CITY OF HAYWARD

AGENDA REPORT

SUBJECT: Zone Change No. PL-2004-0418 and Vesting Tentative Tract Map 7554/PL-2004-0417 – Arlene Utal for Chabot Estate Homes (Applicant)/ Greg Silva (Owner) – Request to Change the Zoning From Single-Family Residential (RS) District to Planned Development (PD) District and Subdivide 2 Acres to Build 11 Homes and Renovate a Historic Home - The Project is Located at the Easterly End of Cryer Street

SUBJECT: **Zone Change No. PL-2004-0418 & Vesting Tentative Tract Map 7554/PL-2004-0417 –Arlene Utal for Chabot Estate Homes (Applicant)/ Greg Silva (Owner) – Request to Change the Zoning From a Single-Family Residential (RS) District to a Planned Development (PD) District and Subdivide 2 Acres to Build 11 New Homes and Renovate an Historic Home**

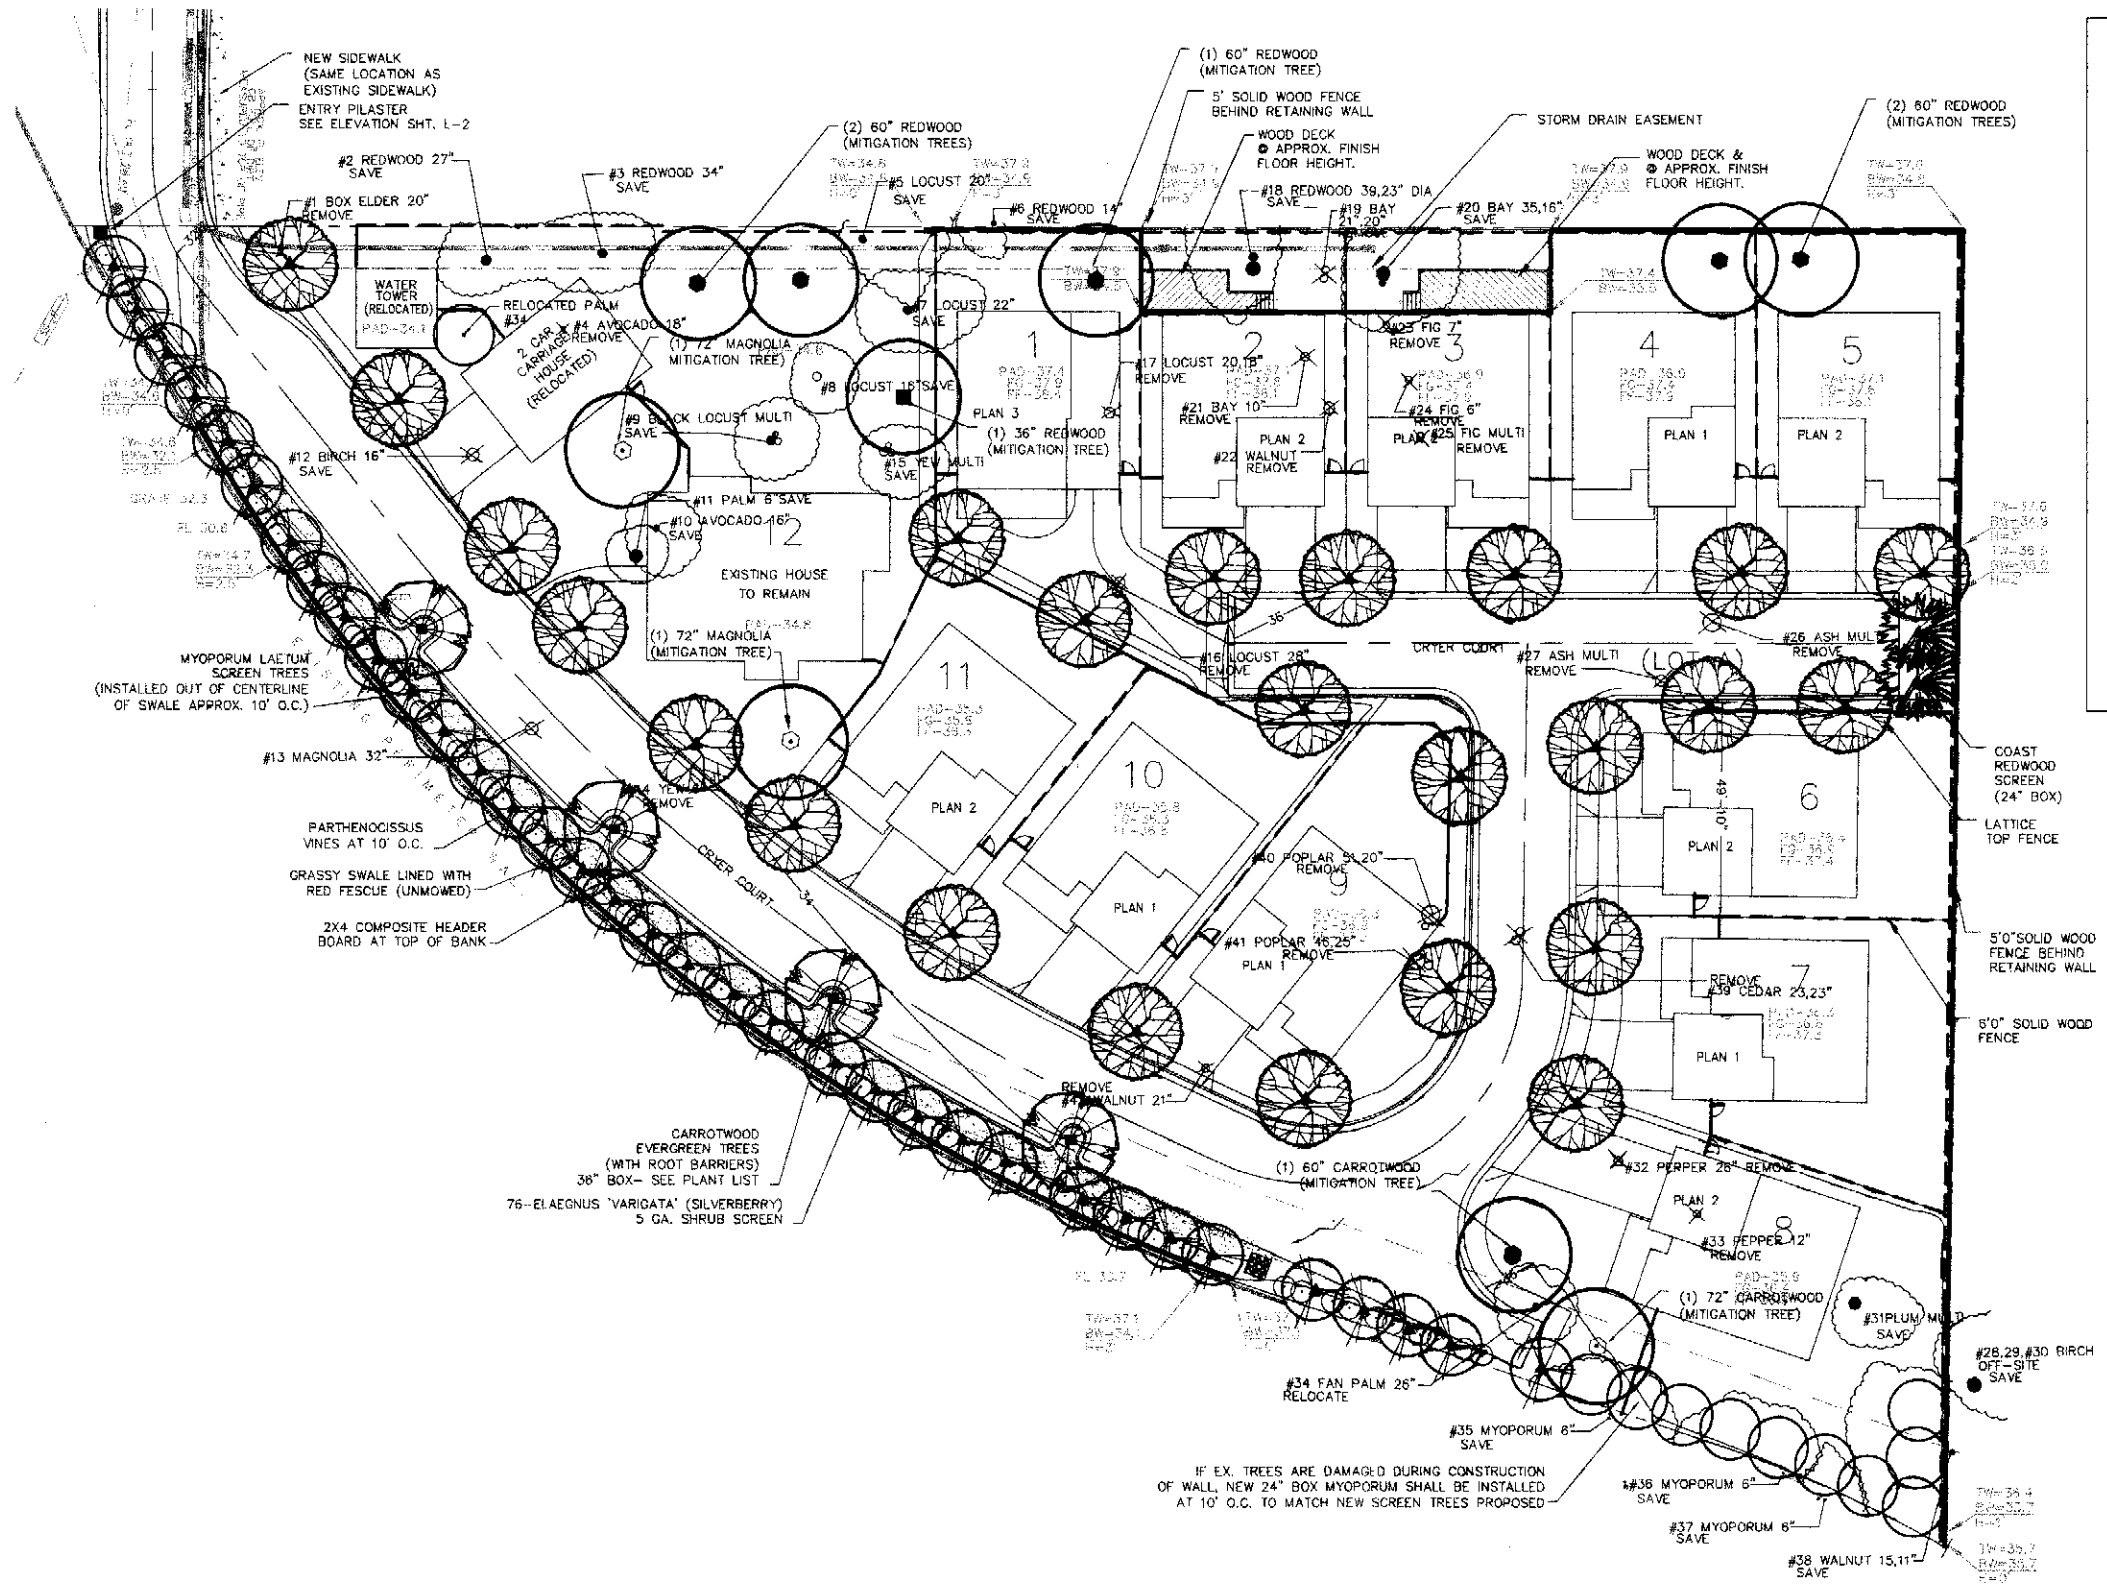
20. The planting plan submitted does not completely address the issue of the required trees for the site. Perimeter screening trees are not being shown in the correct amounts and there are not sufficient street trees being shown in required locations. Parking shade trees appear to be more than sufficient. The required trees must be shown in addition to the proposed mitigation trees.

22. It appears that some of the trees that are proposed to remain (#35, #36, #37, and #38) are in the way of proposed sound walls or fences. Show how this is proposed to be resolved.

23. Carrotwood is considered a sub-tropical is not suitable for this area. It is also a wide, low-branching tree that has a tendency to self seed and should not be planted in lawn areas. Try a taller, higher branching tree such as Koelruteria bipinnata, Acer Rubrum or Ginko biloba.
